Staff Report Z-79-18-7 February 1, 2019

Request To: R1-6 (Single-Family Residence

Proposed Use: Single-family residential subdivision

Location: Northeast Corner of 39th Avenue and

Proposed Site Plan – Source: The William Seymour Company

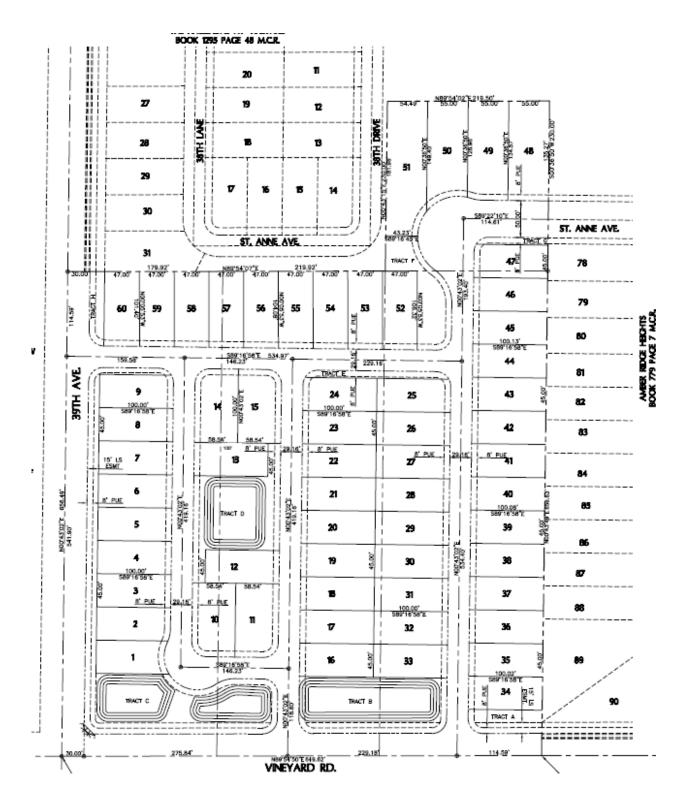
The subject site consists of five parcels and the conceptual site plan proposes 60 single-family residential lots for a density of 5.40 dwelling units per gross acre. There are entrances to the development from 39th Avenue and from Vineyard Road.

The proposed subdivision consists of 45-foot wide lots, 101 feet in depth. The proposed lot sizes are consistent in scale and character with the approved single-family residential developments in the surrounding area.

The conceptual site plan depicts open space areas provided along the southern portion of the site, adjacent to Vineyard Road. Staff has requested an increase in open space provided to 10%. This item is addressed in Stipulation No. 4.

- 4. The developer shall provide a minimum of 10% open space, as approved by the Planning and Development Department.
- 5. Right-of-way totaling 30-feet shall be dedicated for the north half of Vineyard Road for the entire length of the property, as approved by the Planning and Development Department.
